SHDC
Planning & Development

PROJECT
Proposed Residential Development, at ~~Manor Road~~, Holbeach St. Marks, Lincolnshire, For ~~Nashmore~~ Homes

TITLE
Proposed Site Plan

Job Title
**Residential Development
off St Marks Road
Wolbeach St Marks
Hunting
Lincs**

Drawing Title
Plan, Elevations of
4 Bed House at
Plots 5.
"the Rutland"

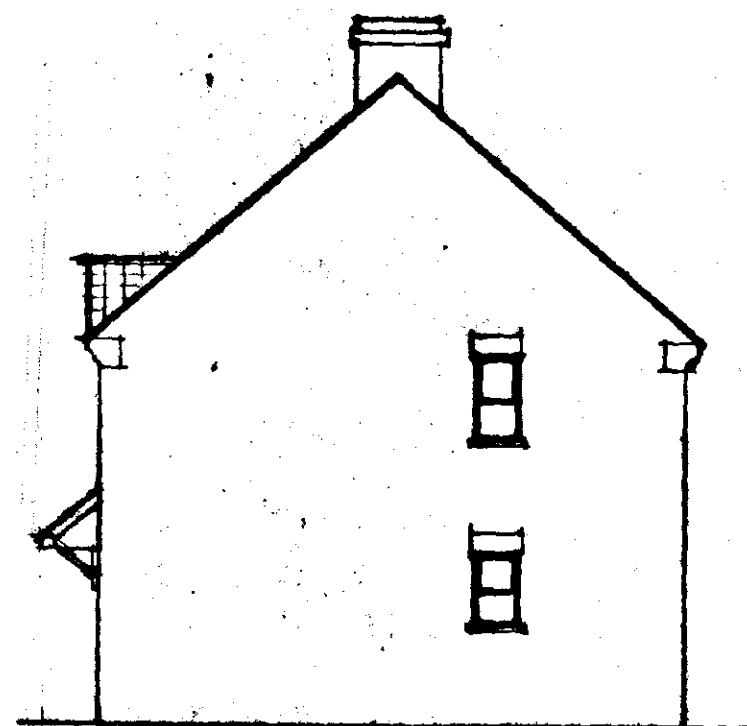
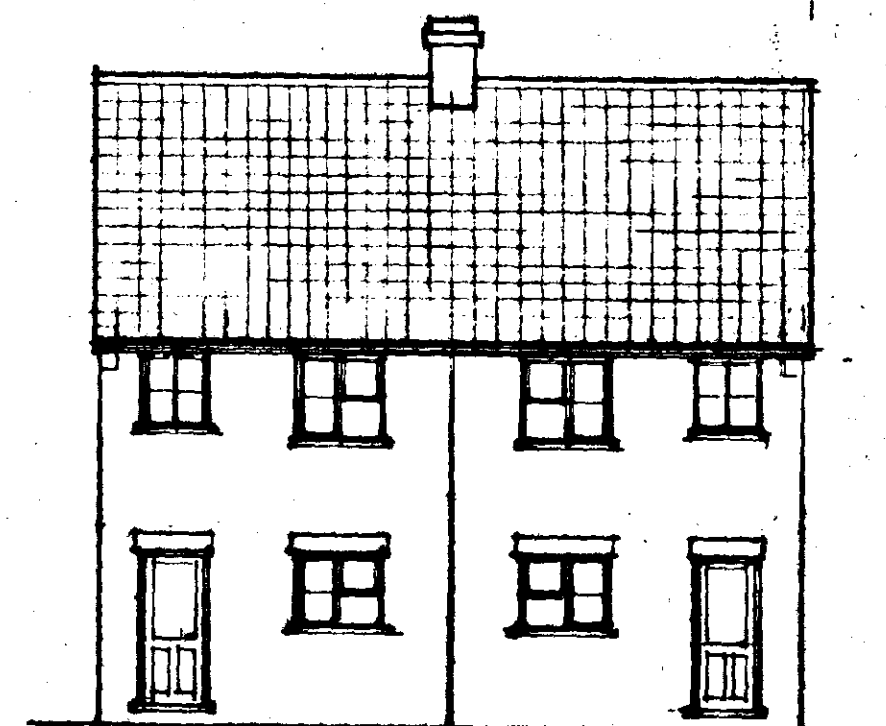
29/03/04 Ref. refers to Plot 5
Conservatory & bay window
added

TITLE
Proposed Site Plan

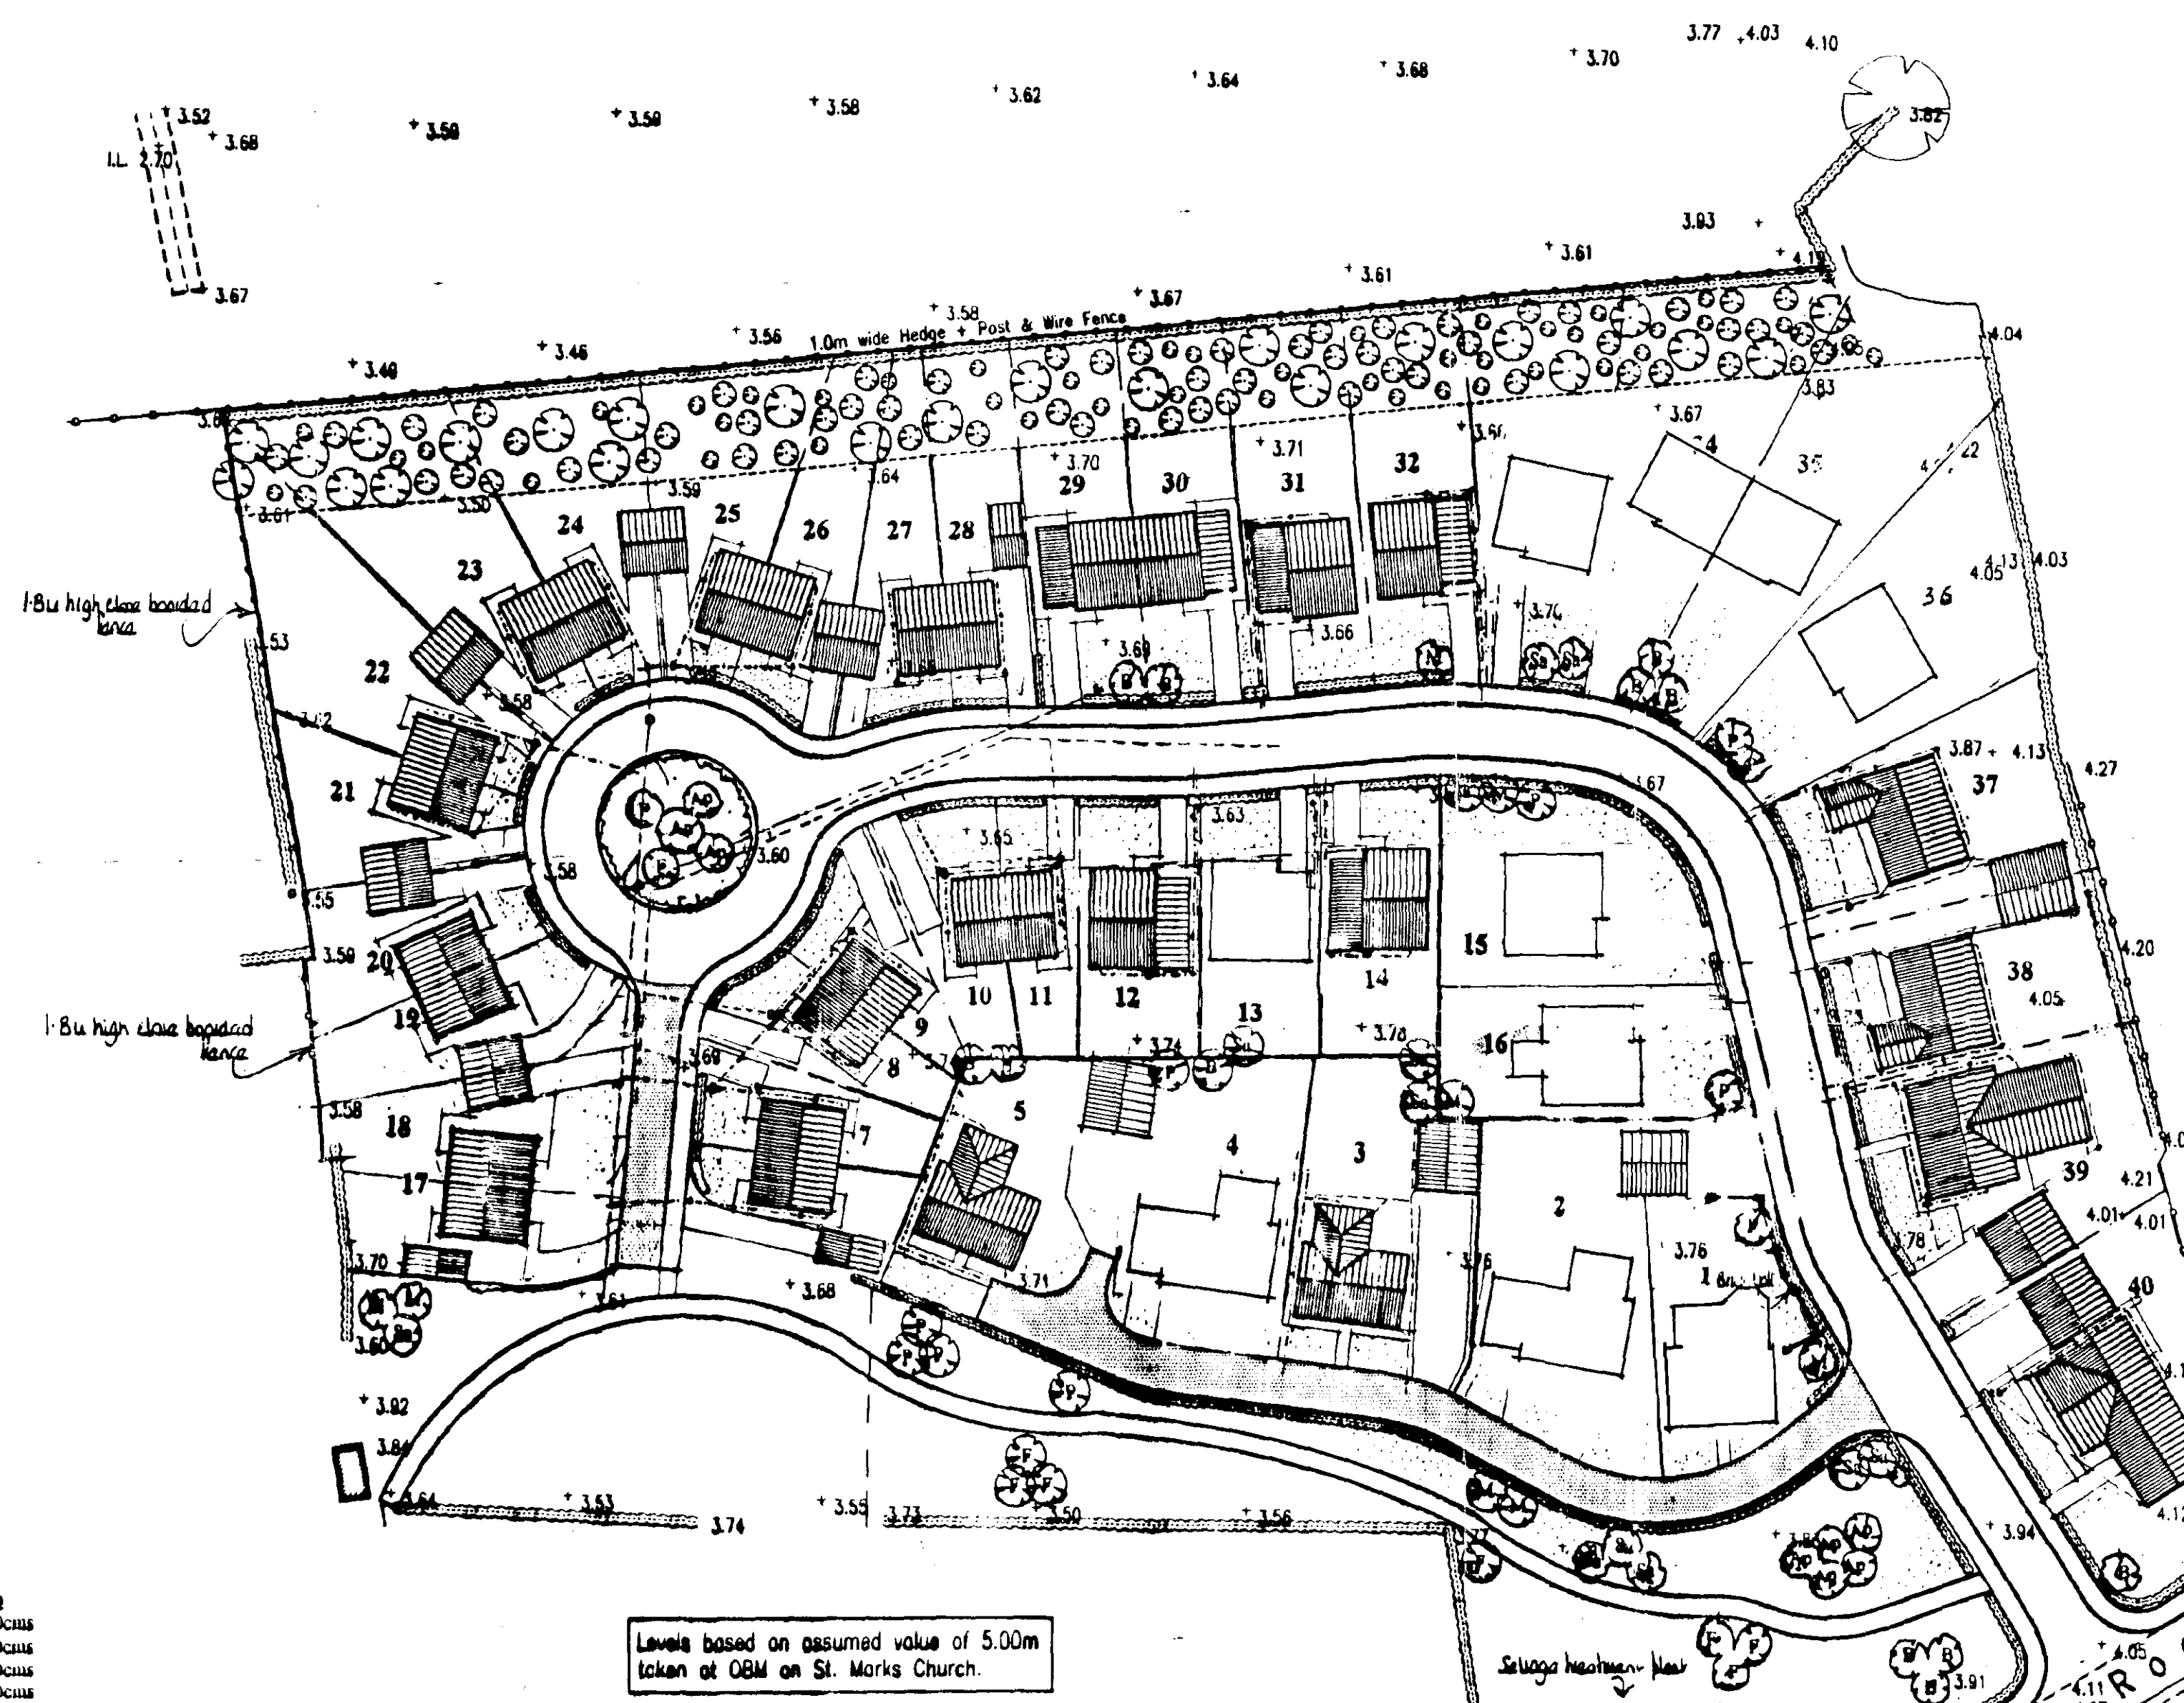
REV	DATE	REMARKS
A	14/01/03	House layout to plot 2, 4 amended.
B	06/02/03	Fence to boundary between plots 2, 4 amended.
C	17/05/02	Drawing revised to clients' comments.
D	16/05/02	Drawing revised to clients' comments.
E	16/05/02	Drawing revised to clients' comments.
F	17/05/02	Drawing revised to clients' comments.
G	18/02/02	Drawing revised to comments dated 18/2/02.
H	15/02/02	Drawing revised to comments dated 14/2/02.
I	13/02/02	Drawing revised to comments made at meeting dated 11/2/02.

Proposed Site Plan

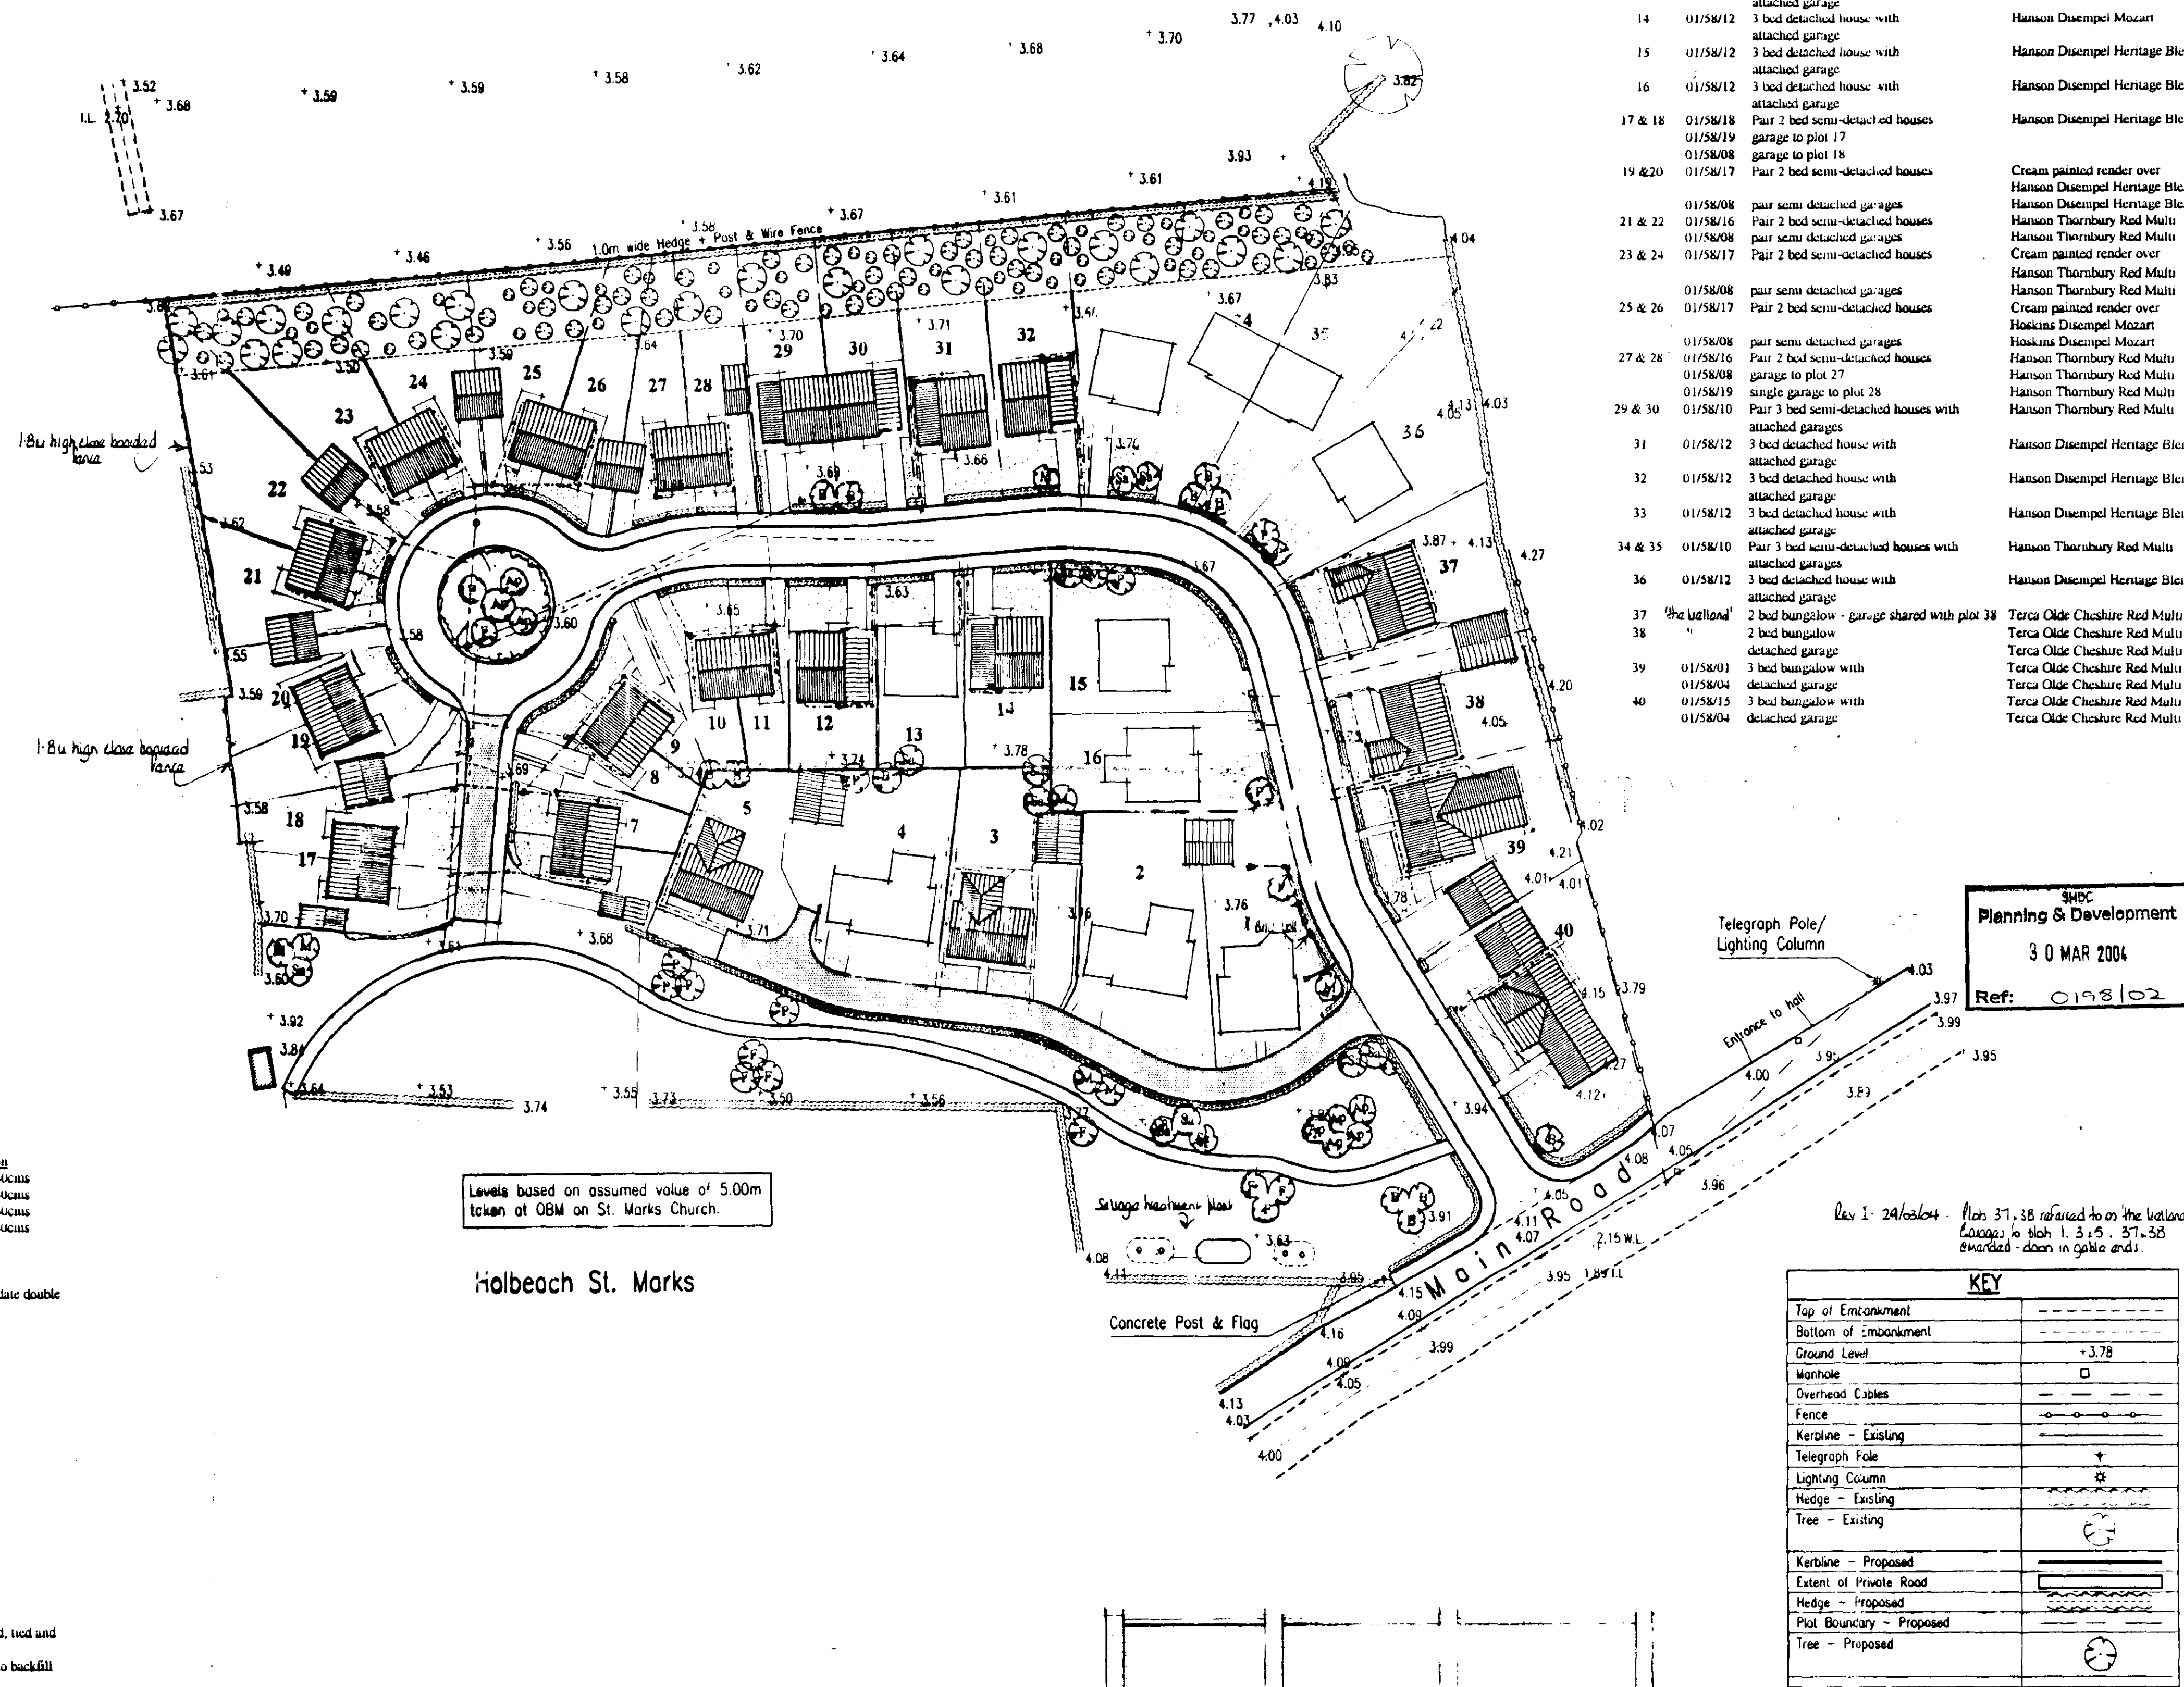
24-02-04 Revision of drawing - Plot 13 - amended
24-03-04 Revision of drawing - Plot 13 - amended
24-03-04 Revision of drawing - Plot 13 - amended
